Access Compliance Report

Public Rights-of-Way

(Curb Ramps)

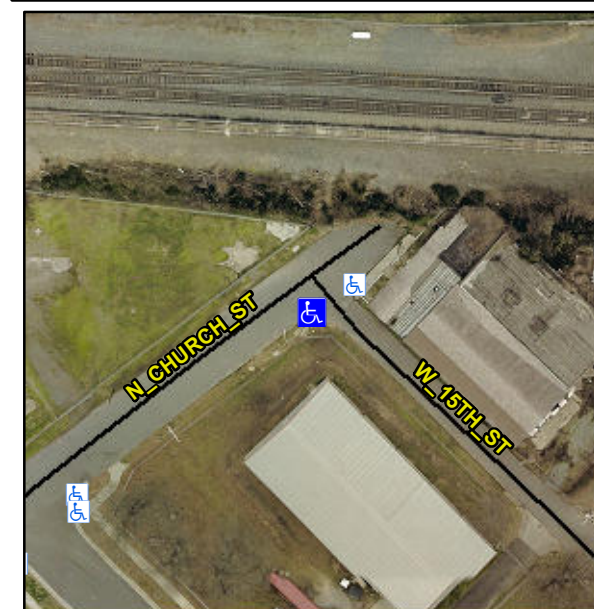
DAMAGED SURFACE

R302.7

Remove & Replace Entire Ramp.
